Re: Florida Power & Light Company  
Proposed Turkey Point Units 6 and 7  
Docket Nos. 52-040 and 52-041  
Response to NRC Environmental Request for Additional Information Letter  
1104071 (RAI 5588) Environmental Standard Review Plan  
Section 9.3.1 – Alternative Site Selection Process

Enclosure: Florida Power & Light Company, Turkey Point 6 & 7, New Nuclear Power  
Generation (Formerly Project Bluegrass) Augmented Site Selection Study  
Report, August 2011

**NRC RAI Number: EIS 9.3.1-2 (RAI 5588)**

- Figure A-1, Dedicated Lands;
- Figure A-2, Critical Habitat;
- Figure A-3, Population;
- Figure A-4, Reclaimed Water Availability; and
- Figure A-5, Surface Water Availability.

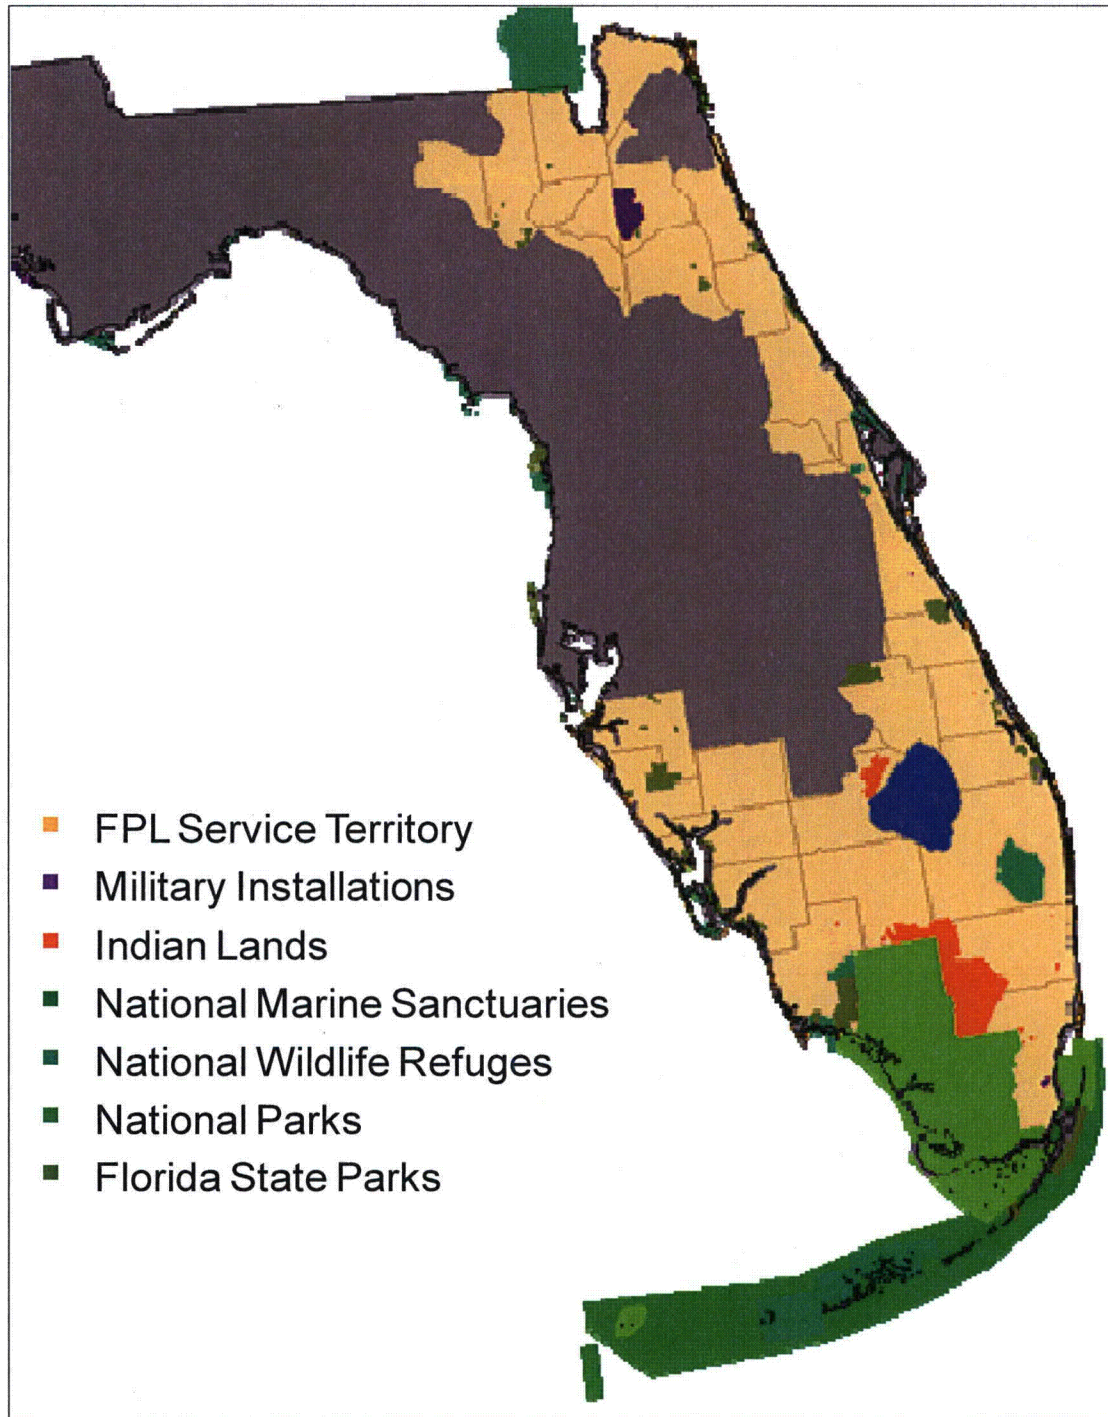
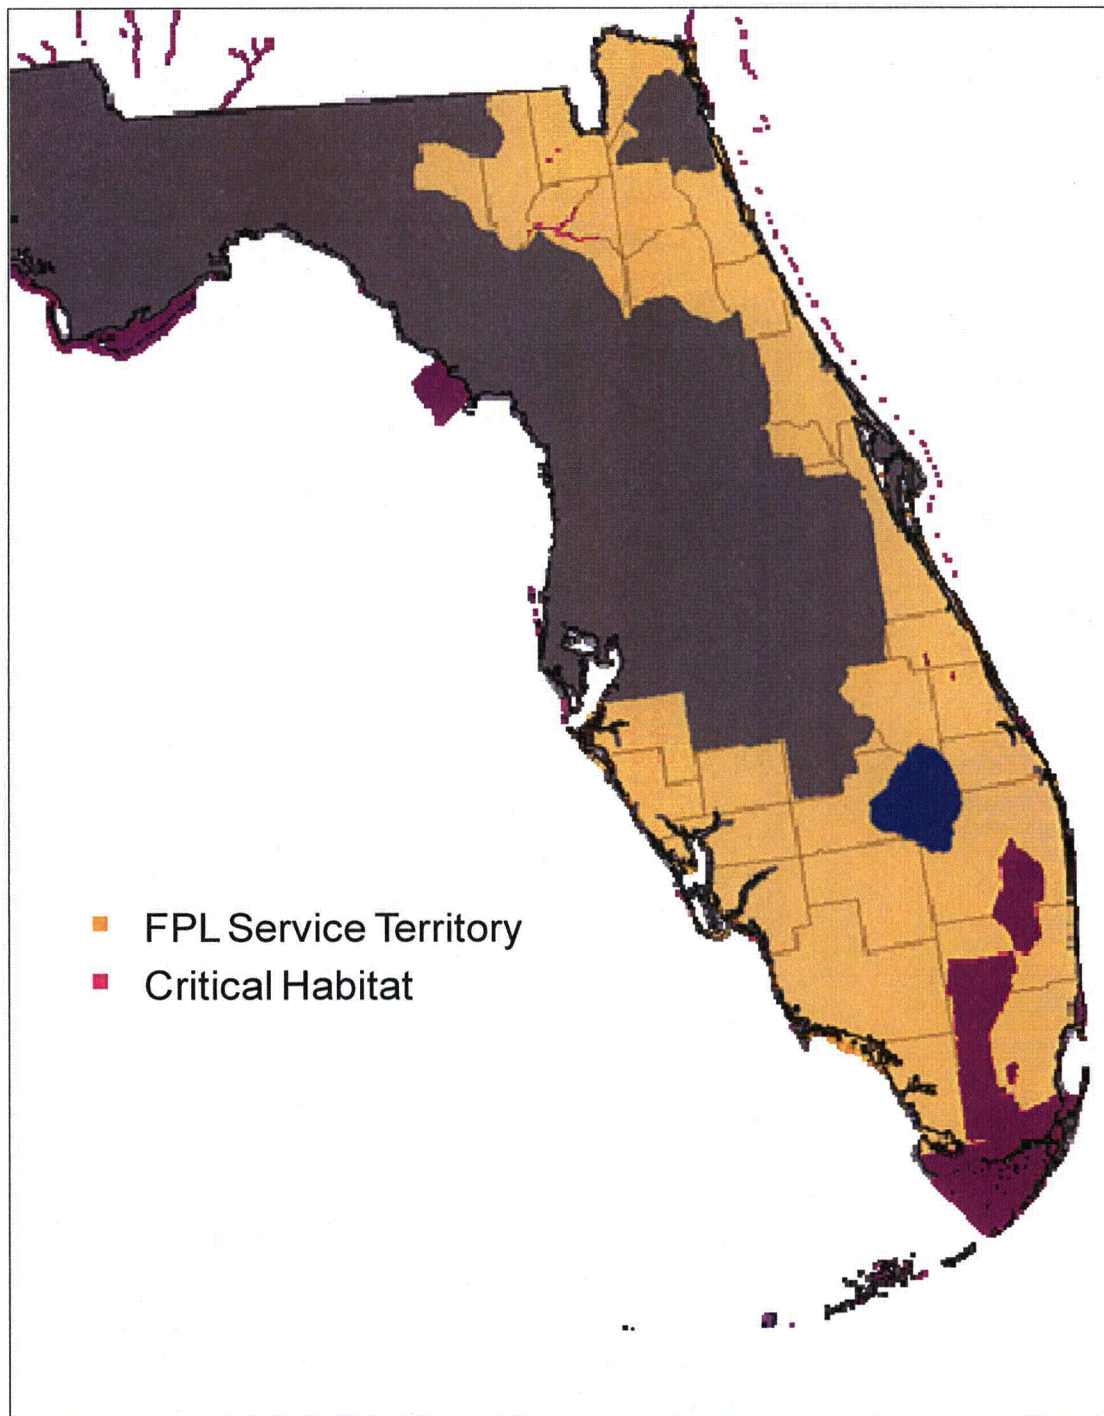
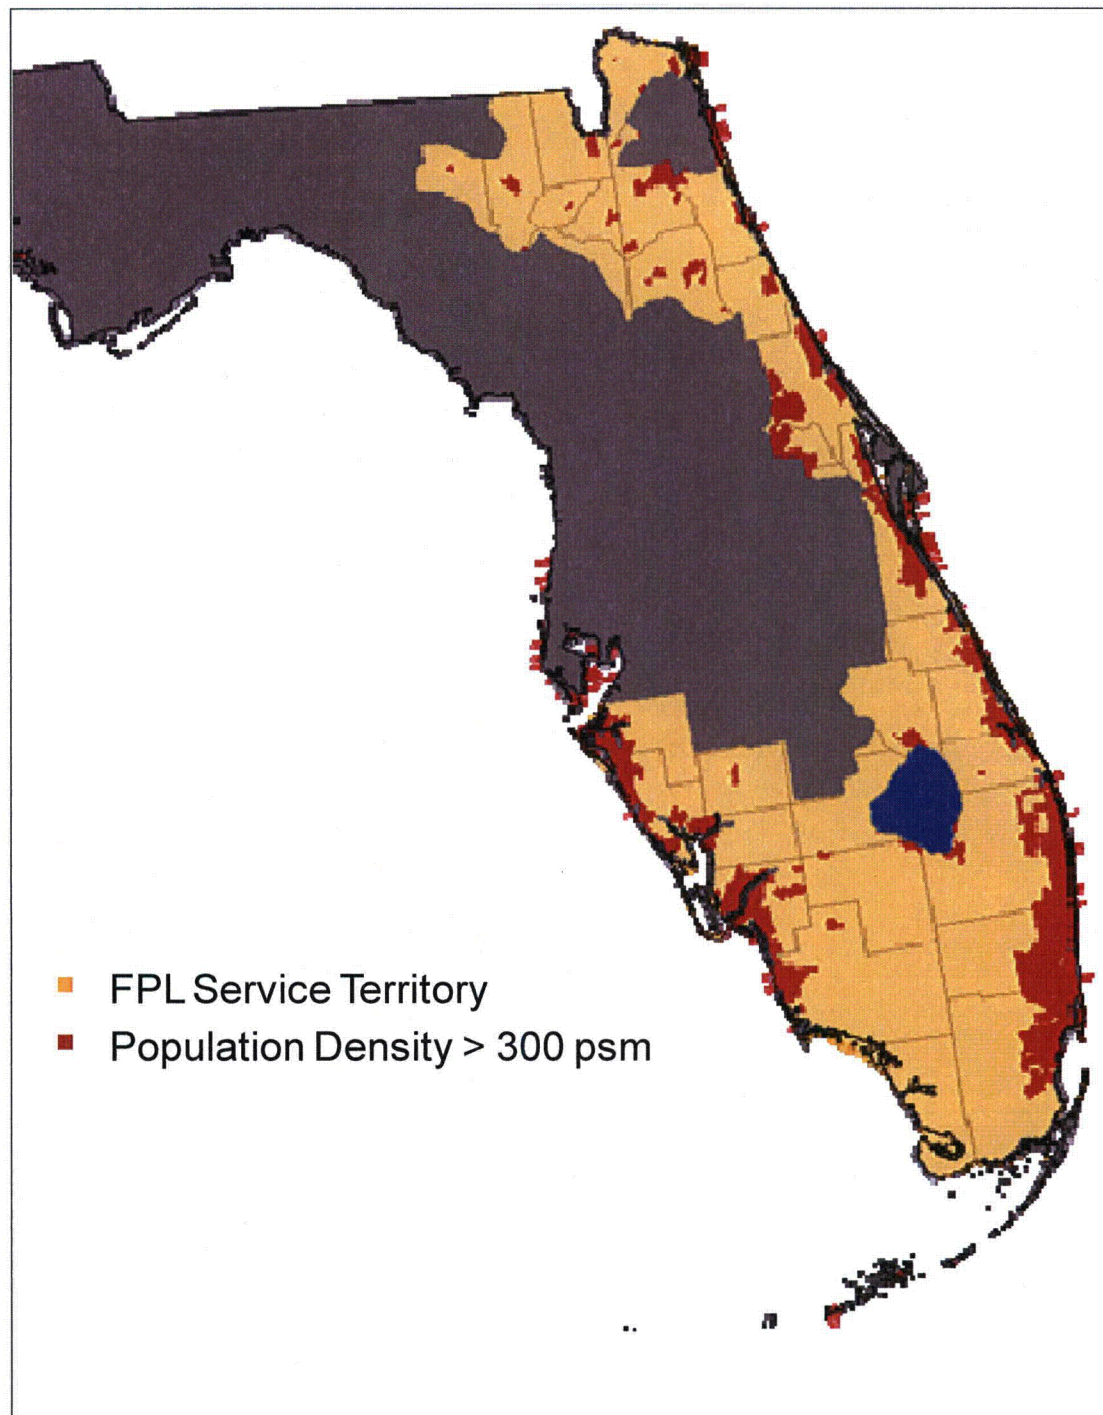
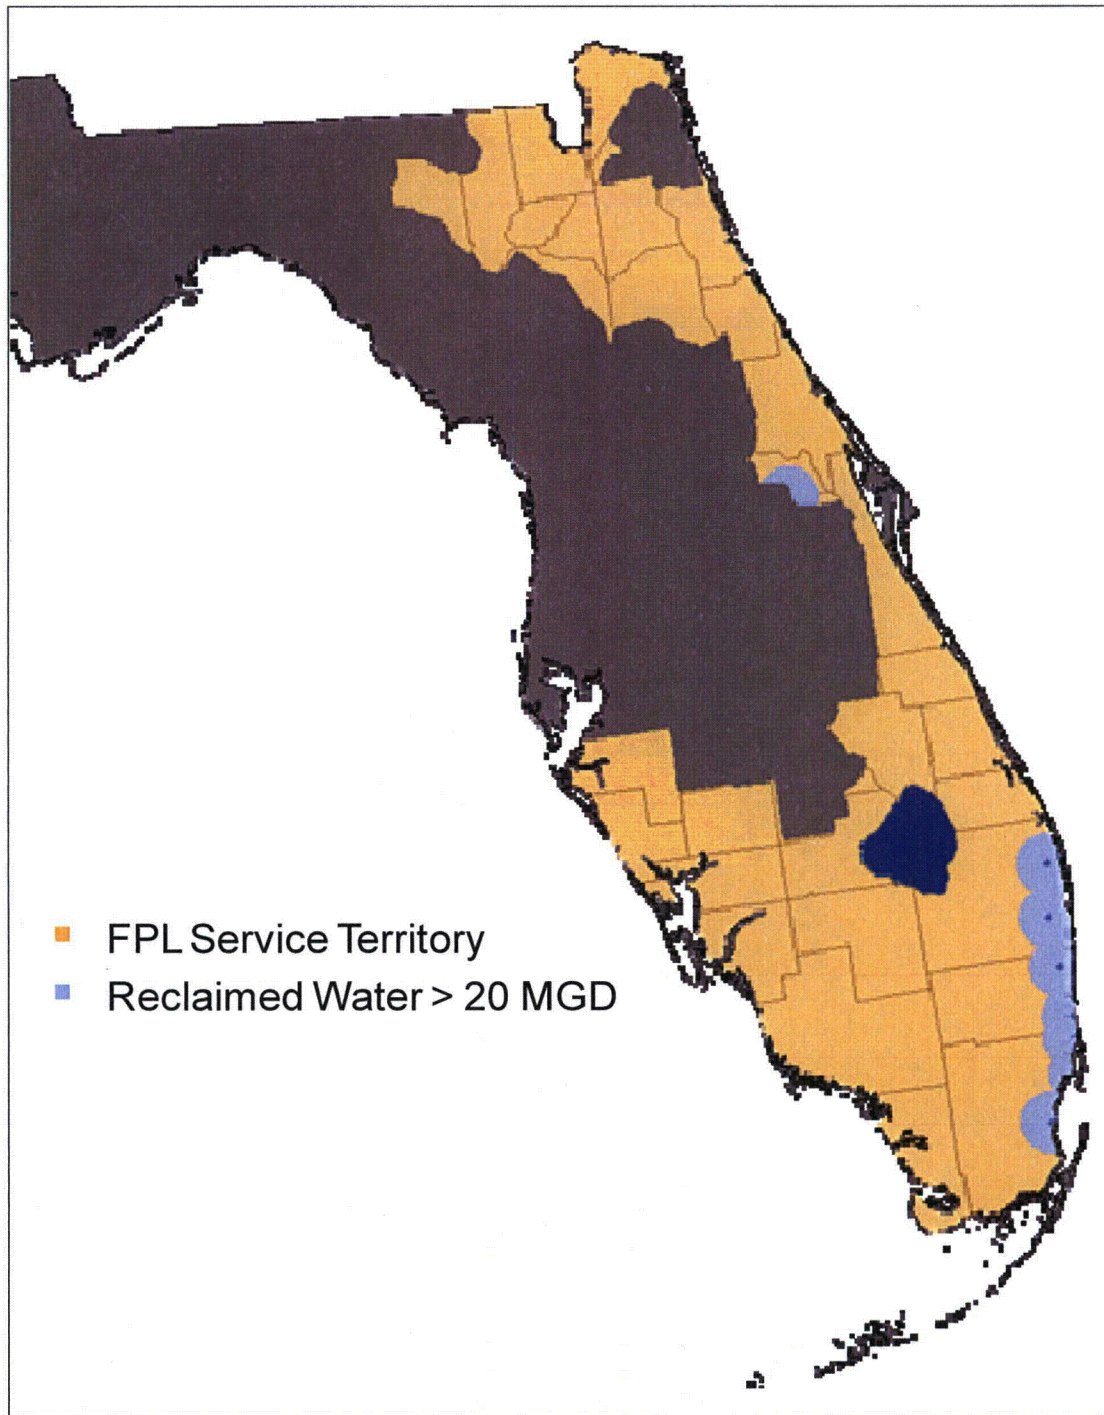
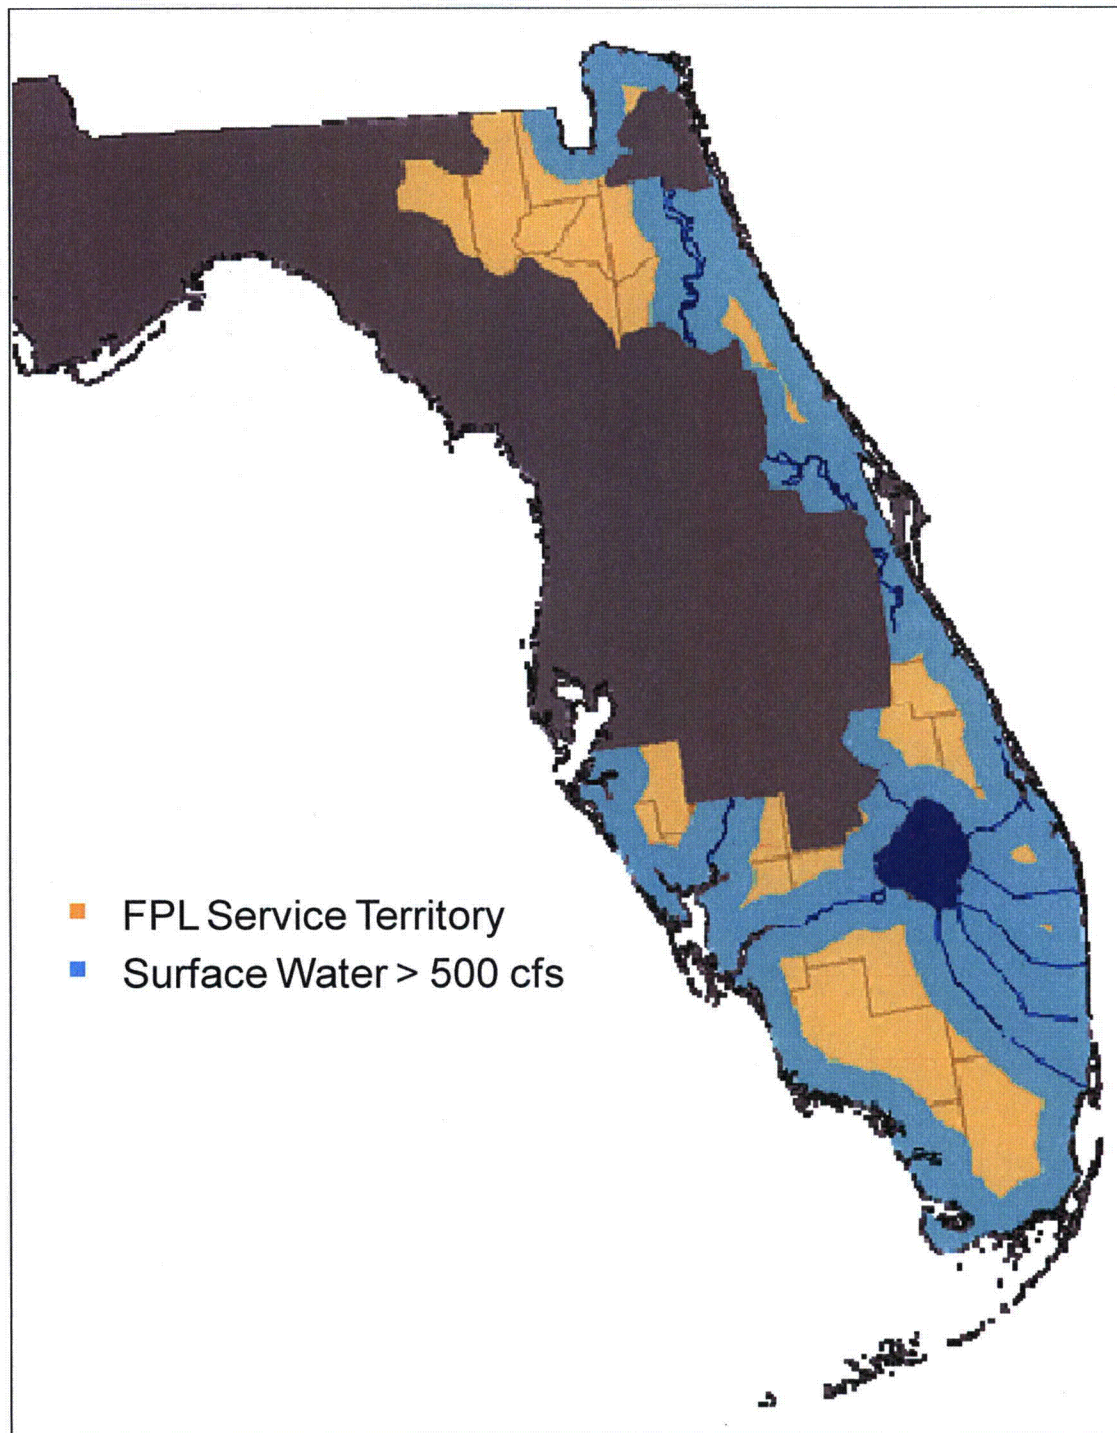
Identify the extent to which the provisions of NRC Regulatory Guide 4.7 and 10 CFR Part 100 were incorporated into FPL's site screening methodology (ESRP 9.3). Provide a formal hard copy of the geographical information system (GIS) information submitted to the reading room by the applicant.

Figure A-1 depicts the results of screening the FPL service territory region of interest for dedicated lands.

Figure A-2 depicts the results of screening the FPL service territory region of interest for critical habitat.

Figure A-3 depicts the results of screening the FPL service territory region of interest for areas of higher population.

Figure A-4 depicts the results of screening the FPL service territory region of interest for areas of reclaimed water availability.

Figure A-5 depicts the results of screening the FPL service territory region of interest for areas of surface water availability.
